UNITED STATES PATENT AND TRADEMARK OFFICE

APPLICATION NO.	FILING DATE	FIRST NAMED INVENTOR	ATTORNEY DOCKET NO.	CONFIRMATION NO.
10/827,273	04/20/2004	Hiroyuki Ishida	Q81168	2403
23373	7590	09/15/2005		
SUGHRUE MION, PLLC 2100 PENNSYLVANIA AVENUE, N.W. SUITE 800 WASHINGTON, DC 20037			EXAMINER DZIERZYNSKI, EVAN P	
			ART UNIT 2875	PAPER NUMBER

Office Action Summary	Application No.	Applicant(s)	
	10/827,273	ISHIDA, HIROYUKI	
	Examiner Evan Dzierzynski	Art Unit 2875

DETAILED ACTION

FIG. 2

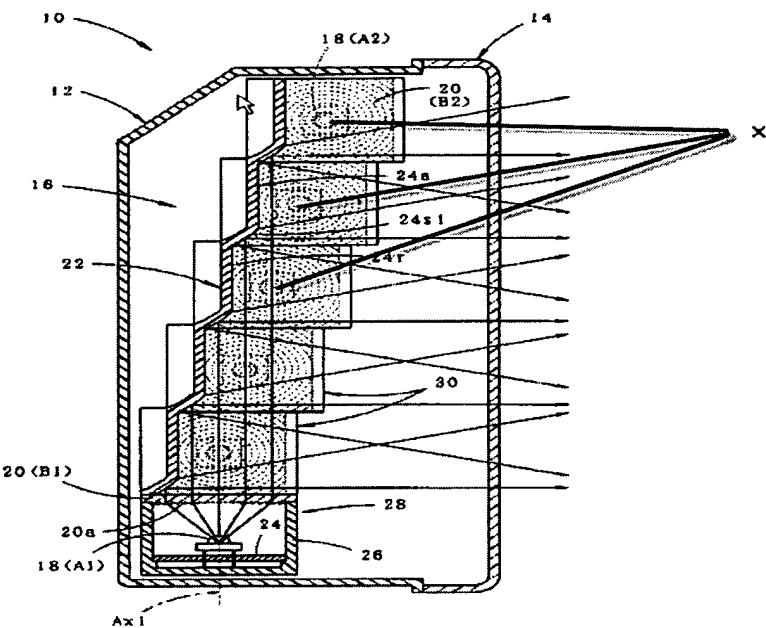
Amano teaches a head lamp that forms a luminous distribution pattern having a horizontal cutoff line (Figure 1 item B) in an upper portion and a protrusion that protrudes upward from the horizontal cutoff line, not numbered in the patent, but drawn in this figure as X.

The lamp of Amano comprises a lighting device unit that conducts illumination for forming the upward protrusion X. Each of the lighting device units are comprised of a light source configured by a semiconductor light emitting device having a plurality of light emitting chips horizontally arranged in a row being forward directed (figure 4.18), Amano also teaches a projection lens disposed in front of the light source that projects an inverted image of the light source toward a front of the head lamp B1.

U.S. Patent Sep. 16, 2003 Sheet 3 of 8 US 6,619,825 B2

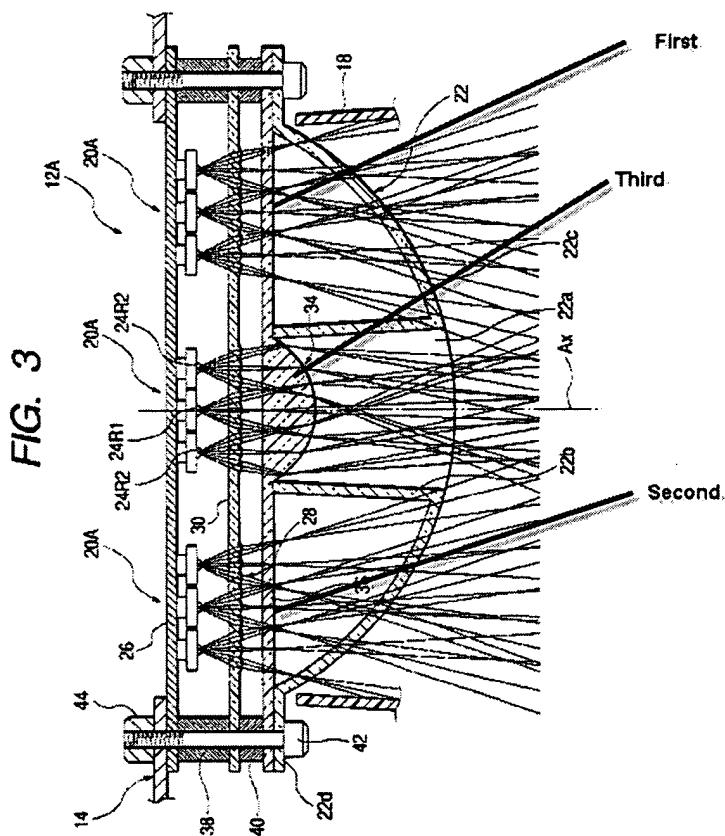
As for claim 7, Naganawa and Amano teach the lamp of claim 6, but fail to teach a focal length of the third lighting system that exceeds a focal length of the first lighting system and a focal length of the second lighting system, and that the first and third light systems form the horizontal component. Natsume teaches a lamp wherein a focal length of a third lighting system exceeds a focal length of the first lighting system and a focal length of the second lighting system, and that the first and third light systems form the horizontal component (focal length not labeled in patent, added into drawing below).

It would have been obvious for one of ordinary skill in the art at the time of the invention to combine characteristics of the focal lengths of Natsume with the lamp of Naganawa and Amano in order to provide the lighting system with a more wide array of light, since there will be more directions for it to travel in as it passes through the different lenses.
